X3T10/855A

revision 03

draft proposed amendment #1 to American National Standard
Information Technology -
SCSI-3 Parallel Interface

Figure 1: SCSI-3 document road map

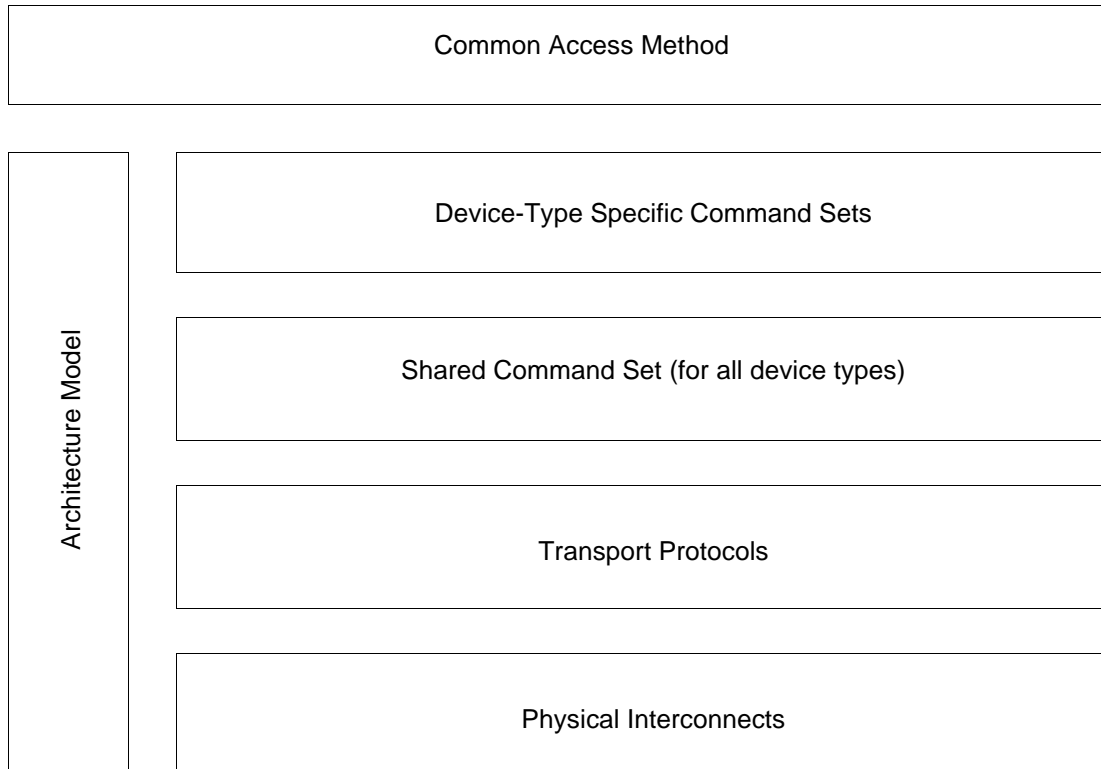
Replace figure 1 with the following:
